REV.
D

AS1895™/8

FLANGE, MALE, BUTT WELD
TYPE II LOW PROFILE

FIGURE 1 - TYPICAL SECTION

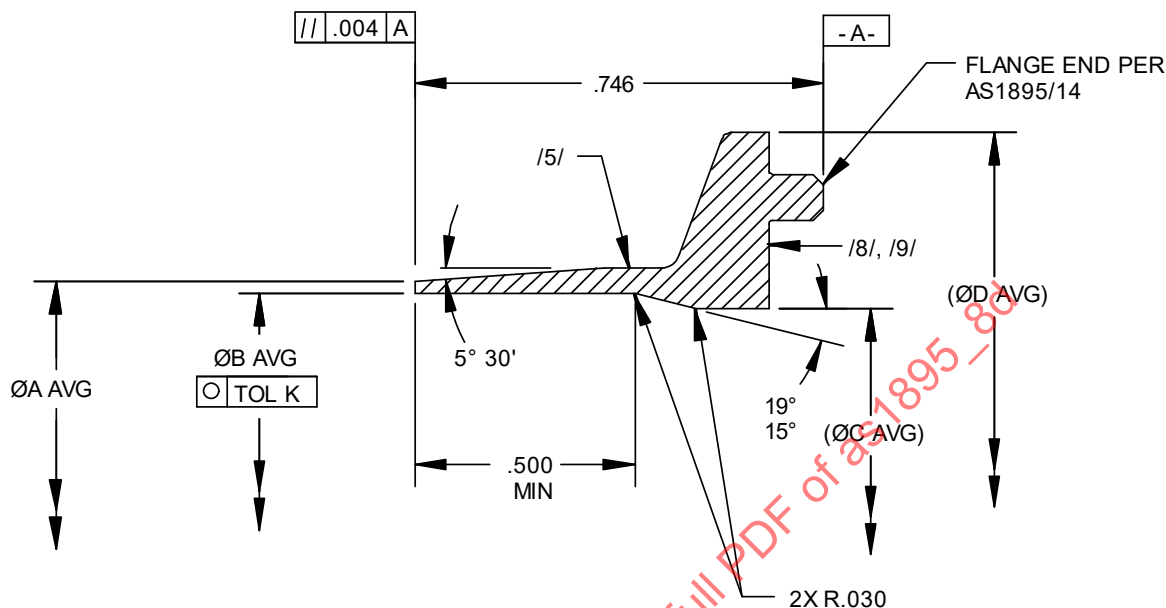
GRAPHICS REDRAWN. CIRCULARITY REQUIREMENT REMOVED FROM ØA. PERPENDICULARITY REQUIREMENT REMOVED FROM REFERENCE ØC. TABLE 1 REDRAWN TO ADD "REF" TO DIM C AND D. NOTE 3 REVISED TO STATE CURRENT QML NOTE. GENERAL UPDATING OF SPECIFICATIONS BEING SPECIFIED HEREIN. CHANGE BAR NOTE REVISED. NOTE 17 ADDED.
